**ADDISON AIRPORT
BUILDING REPORT**

Facility Information: **Facility Name:** Pilot Lounge North
Facility Contact: Lisa Pyles **Contact Phone:** 972-450-2878

Accessology Inspector Information:
Inspector: Karen Jackson **Date:** April 17, 2017
Email: Kjackson@accessology.com

Violation 8 - The centerline of the water closet is at 21-1/2".

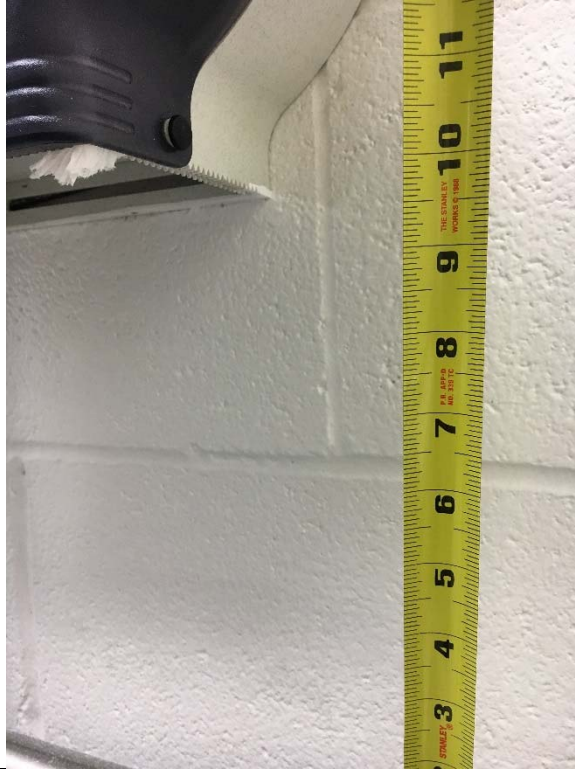
The centerline of the water closet is at 21-1/2".

Re-mount water closet so the centerline is between 16"-18".
